EAST KILDONAN - TRANSCONA
RESIDENTS' ADVISORY GROUP
REPORT TO
East Kildonan / Transcona Community Committee
Agenda August 13, 2026

Notes Prepared August 10, 2026

4. **Plan Approval – 271 Grassie Boulevard**
   If this build is to go forward, and we're not saying it shouldn't, it needs better access into the site. Currently, access in and out of this parking lot

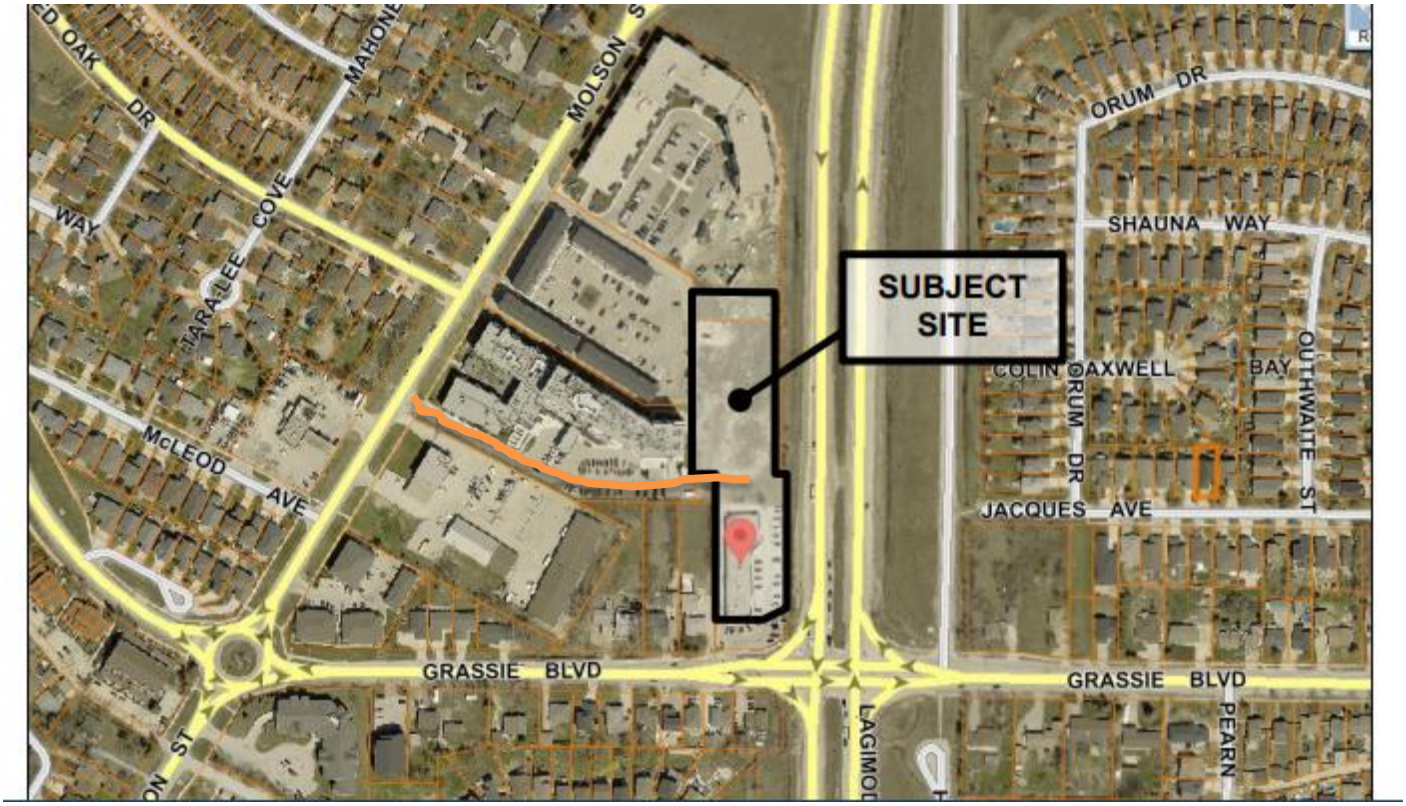
is very limited during certain times of the day and at all times of the day only right hand turns are allowed, increasing traffic onto Grassie. One suggestion would be to add an additional access point to the building from the Molson side. According to the plan provided there is a road that runs between the River East / Transcona Maintenance Yard and Bergen Gardens. This road could be extended to provide access to both buildings. This would provide better access in and out of the site.

(Orange line added to show alternative access)
